**CITY OF DANIA BEACH
COMMUNITY DEVELOPMENT DEPARTMENT
STAFF REPORT**

SUBJECT: **WA-37-12 / SP-10-12** - The applicant, ACAI Associates, Inc., on behalf of Broward County Board of County Commissioners, is requesting a waiver and site plan approval for new bus depot, maintenance facility, administrative offices and associated parking garage at property located at 5440 Anglers Avenue.

Site Plan: Ravenswood Bus Maintenance Facility (SP-10-12)

Ravenswood Bus Maintenance Facility
Site Plan Review No. SP-10-12
5440 Ravenswood Road
Dania Beach, Florida

SHEET NUMBER: LA-105

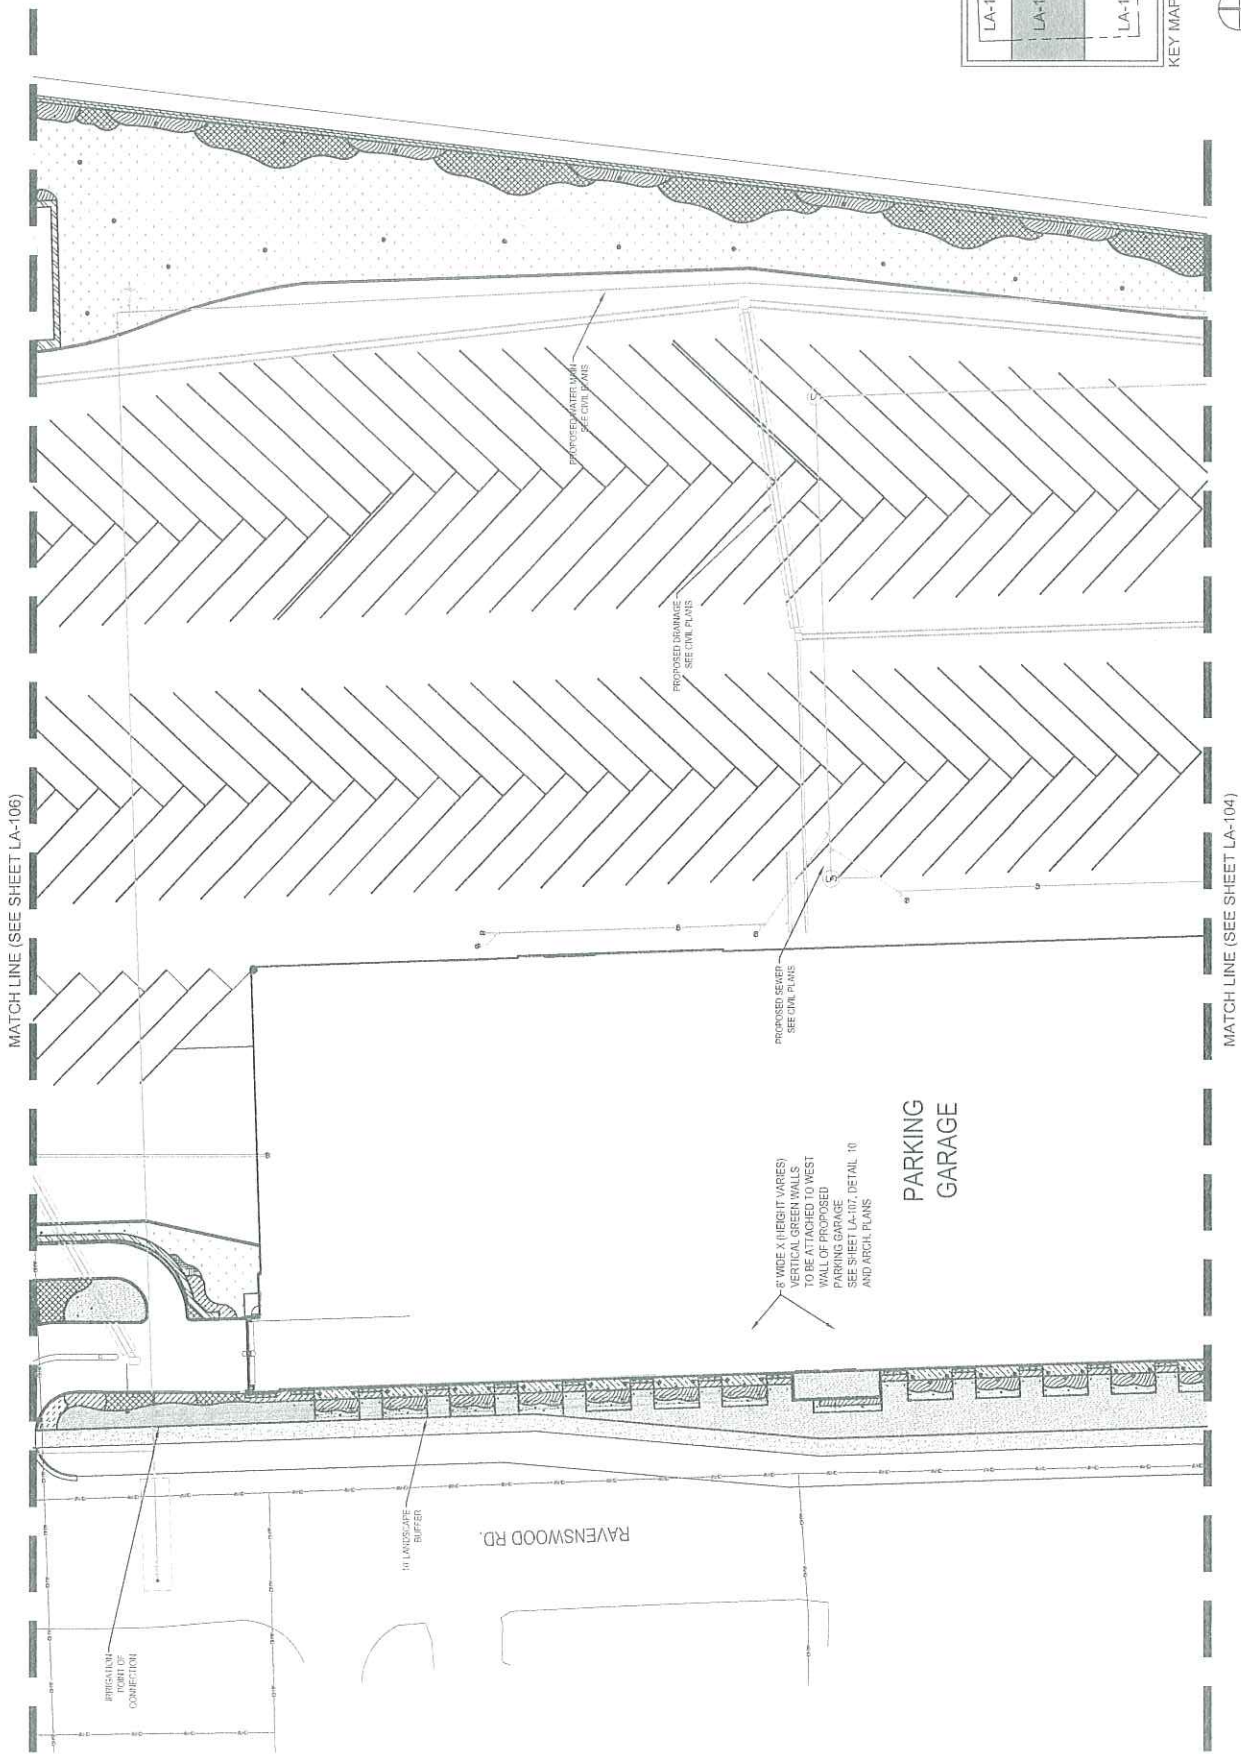
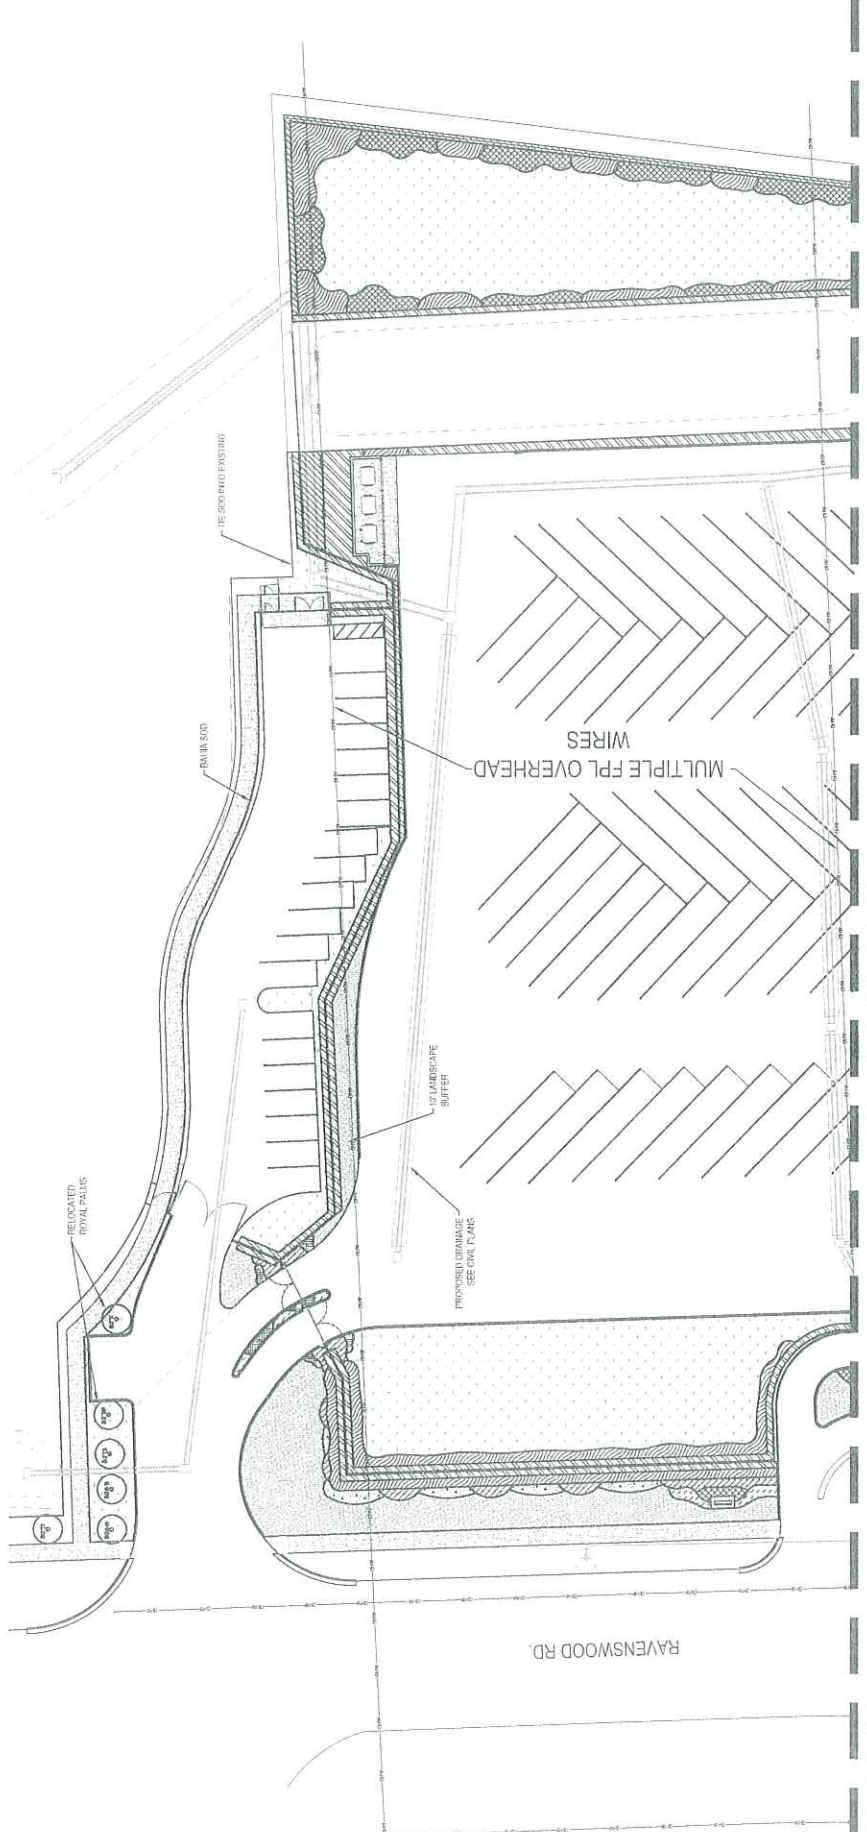
12. Up size trees on perimeter where feasible (added 8-2-12) (Planning). This is a new comment that has not yet been satisfied.

This is a new comment received after the 7/26/12 site plan resubmittal. Revised landscape plans showing the new tree sizes agreed upon by the City and County are included with this resubmittal

10 GREENSCREEN PANELS
 SECTION

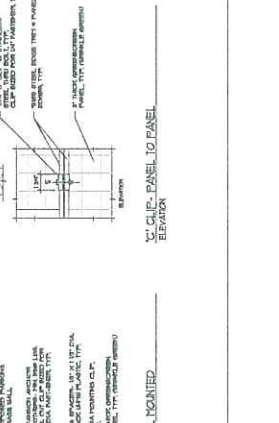
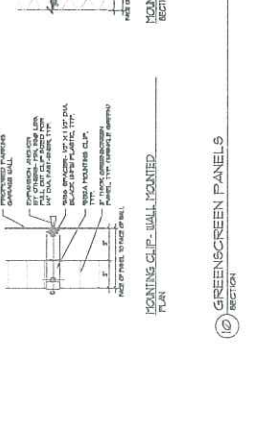
32. Provide screening detail for the open space of the garage facing Anglers Avenue (comment added 7-10-12).
33. Up size trees on perimeter where feasible (added 8-2-12).
